SUBJECT: Coastside Design Review Continuation
Cortez Avenue, Miramar
APN 048-032-070; County File No. PLN 2018-00397

At its meeting of May 9, 2019, the San Mateo County Coastside Design Review Committee (CDRC) considered your design review application to allow construction of a new 1,732 sq. ft., two-story single-family residence, plus a 380 sq. ft. two-car attached garage, located on an existing 4,400 sq. ft. legal non-conforming parcel (legality confirmed via PLN2014-00116), as part of a hearing-level Coastal Development Permit (CDP) and a Non-Conforming Use Permit (UP). The UP is required to allow development on a non-conforming parcel with proposed right and left side setbacks of seven (7) feet each, where ten (10) feet is the minimum allowed for each side. No trees are proposed for removal. The CDRC was unable to make the findings for design review recommendation of approval based on certain design deficiencies. In order to resolve these deficiencies in the project's design, a more thorough review of the "Standards for Design for One-Family and Two-Family Residential Development in the Midcoast" manual is required, with emphasis on Section 6565.20(C)2. Complement Other Struct

3D Views are Not to Scale and May Not Reflect The Actual Conditions

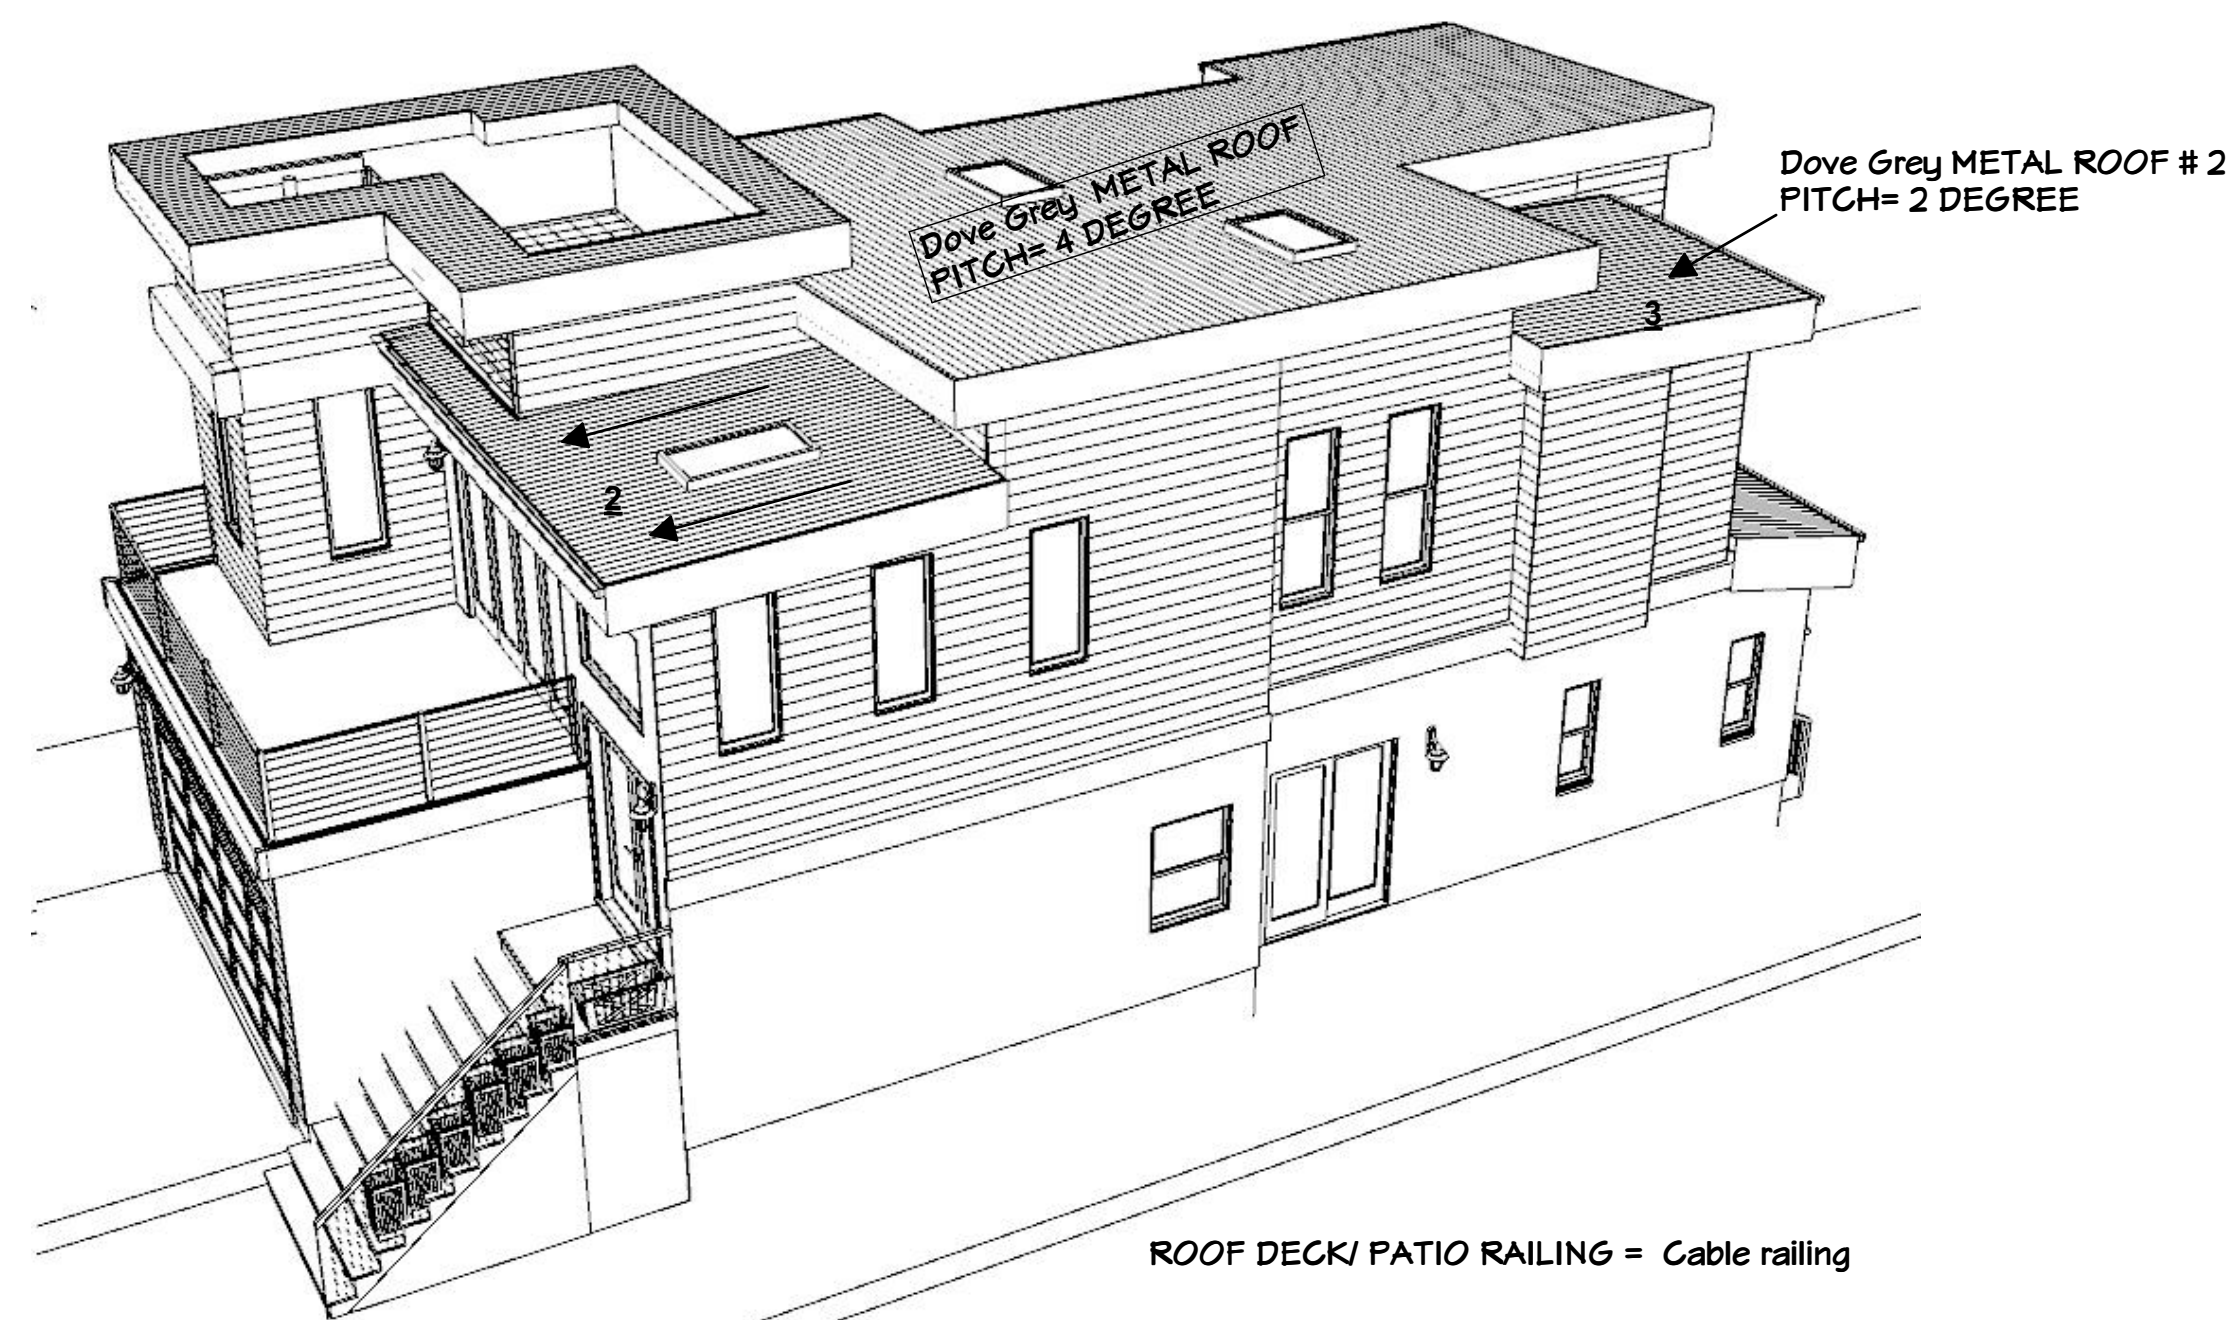
8. Consider eliminating the roof deck to ensure neighbor's privacy.
9. Vertical proportions on the right side of the residence need to be addressed along with the ones on the front facade.

5. Reduce second floor roof height at front of house and reduce visual mass by providing varying eave heights. Consider using a roof form that combines sloping sections in order to reflect other houses in the area.

ROOF FACIA BOARD WIDTH = 18 inches (Box Soffit)

Roof Deck completely hidden , integrated into the roof design

ROOF DECK AREA = 120 Sft now (Rev 3= 194 SQFT) (Rev 2 = 300 SQFT)

Exterior LIGHTENING Plan

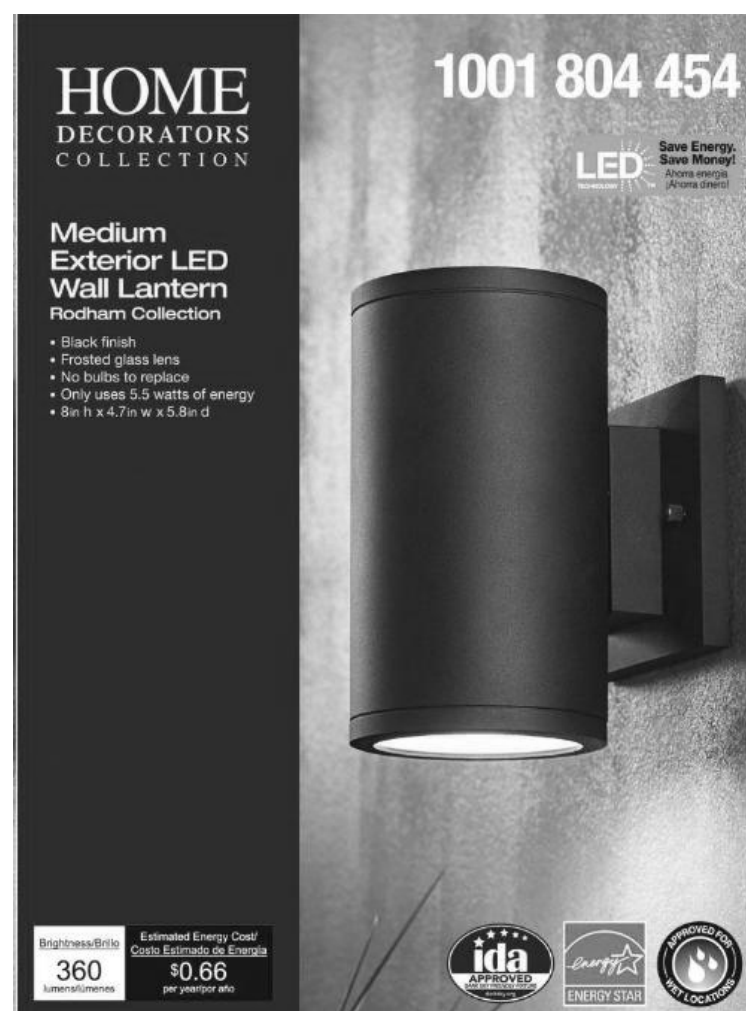
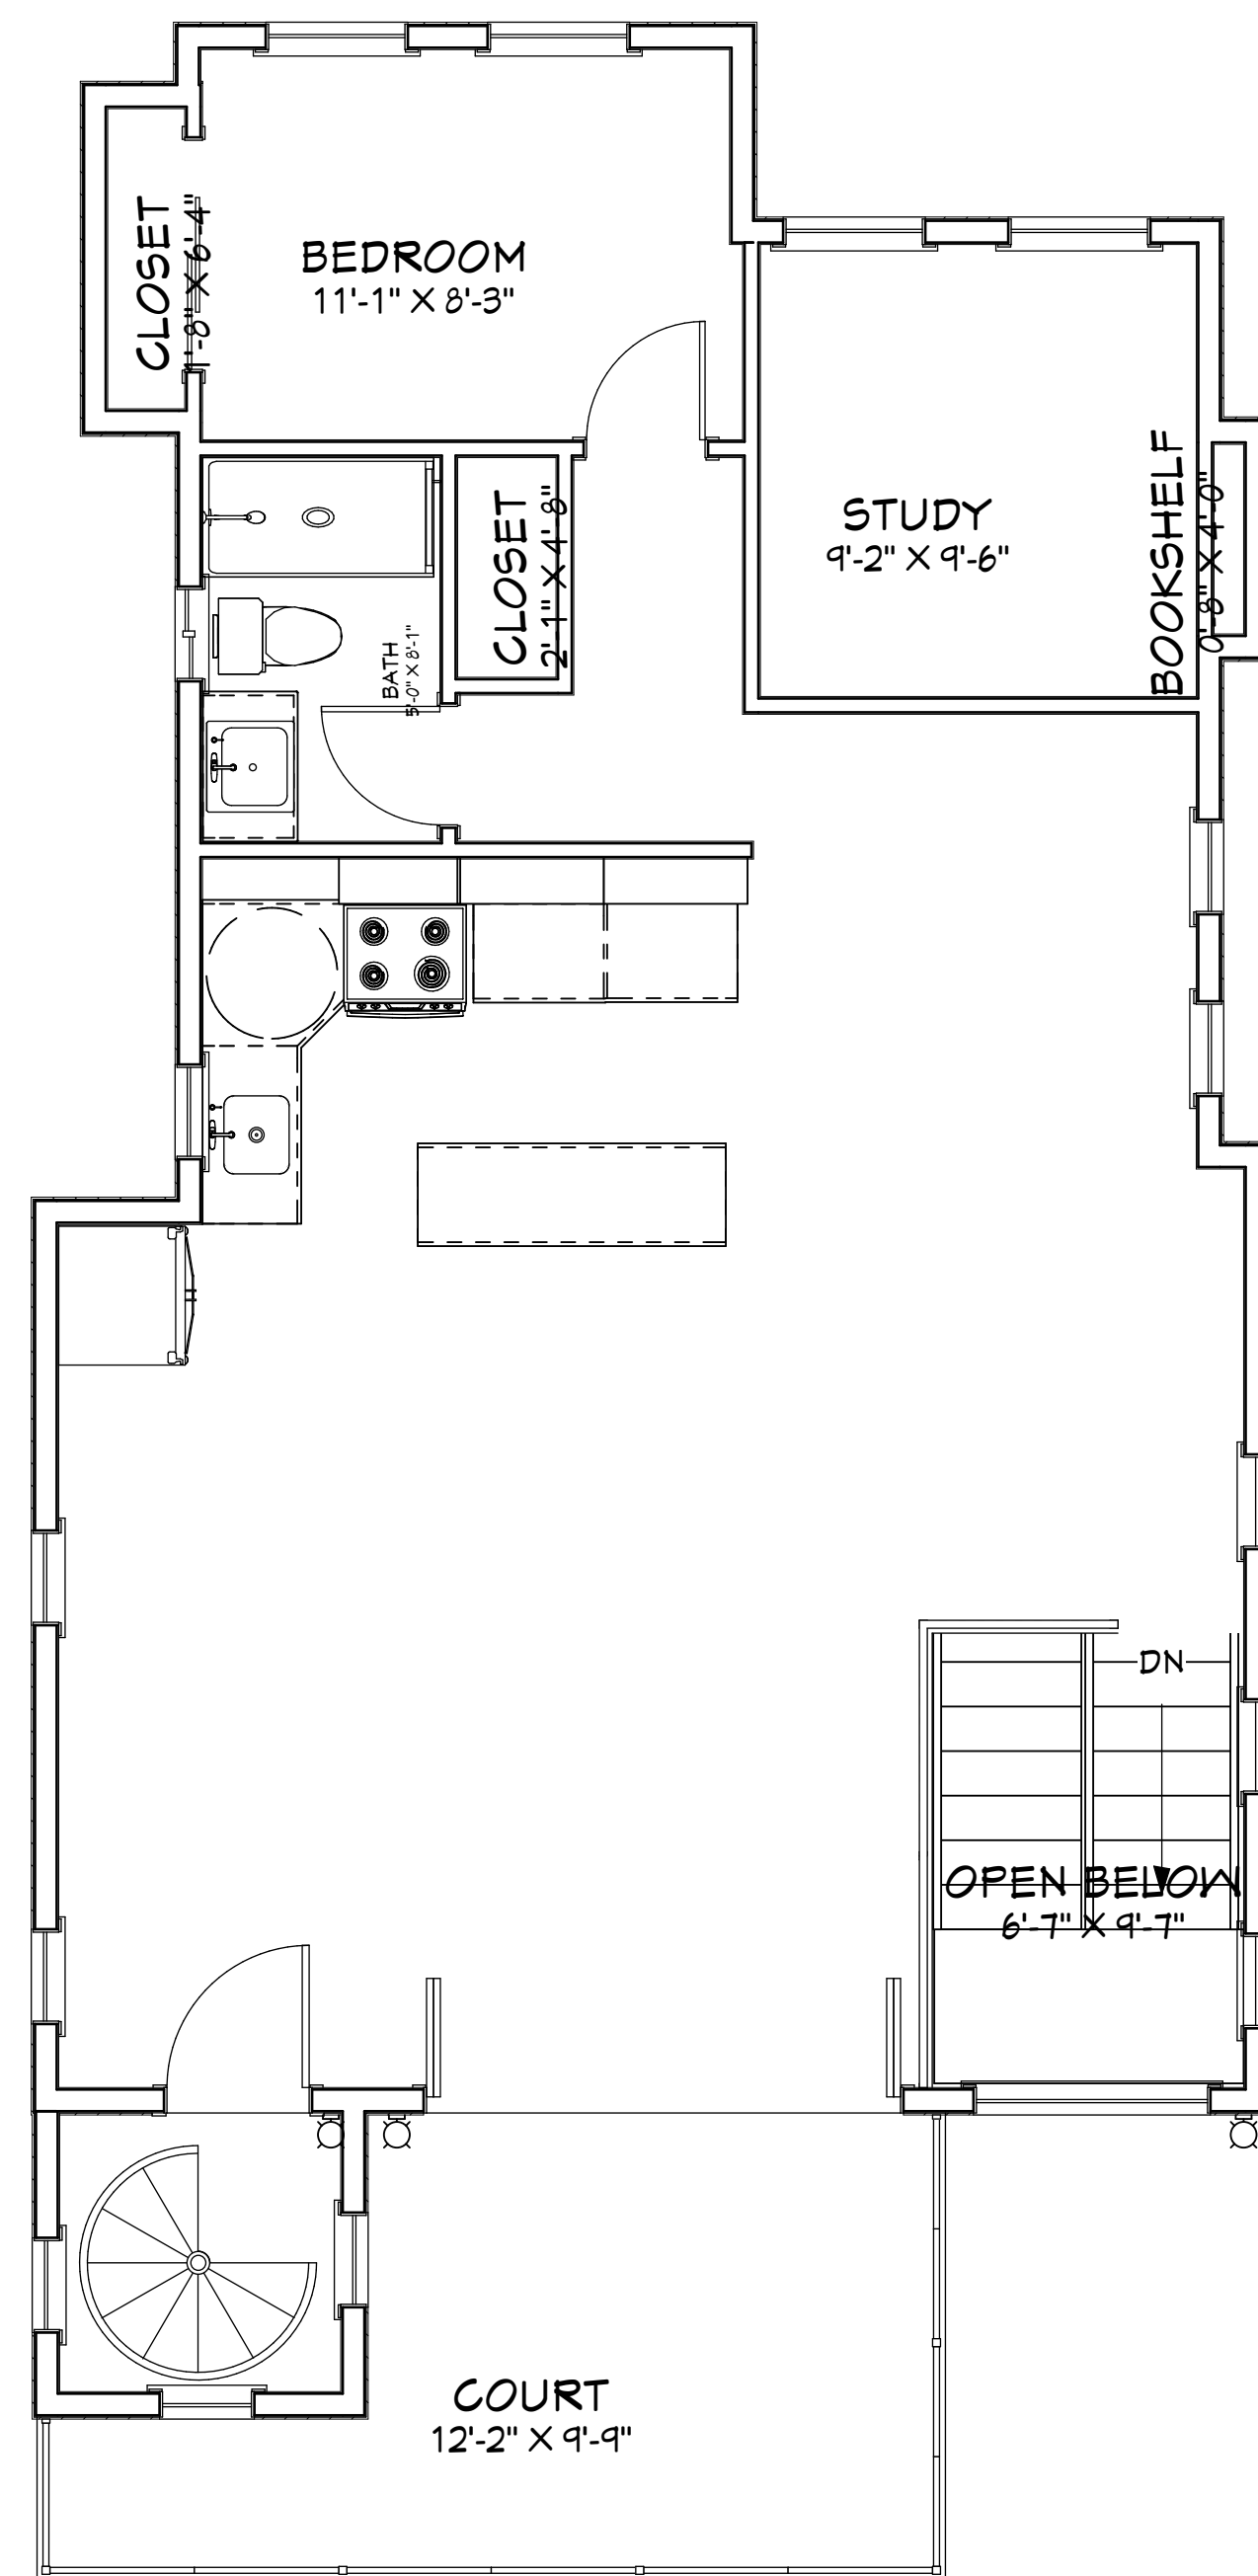
1. Outdoor lighting reduced to one light fixture near doors only
Redesign: Remove all lighting. Total exterior light now reduced to 5. 2 for front patio and then 1 each exterior door.

Reduced Ligtening only 5 exteiror lights total
